PREVOST

WARRANTY BULLETIN

Wb03-09

SUBJECT: REPLACEMENT OF BALL STUD NUTS ON

FIGURE 1

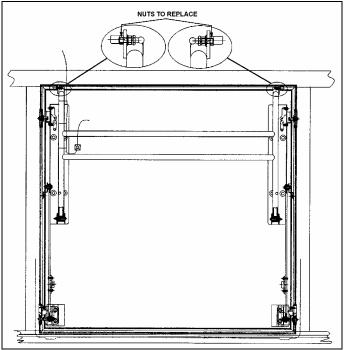
On the above-mentioned vehicles, the fixing mechanism for the baggage compartment door cylinders <u>may</u> be defective. Improper nuts have been used by mistake with the ball studs and therefore may not safely support he doors.

2. Replace the two nuts onto each baggage compartment door as per figure 1 and 2.

Part No.	Description	Qty
502838	Nut	A/R
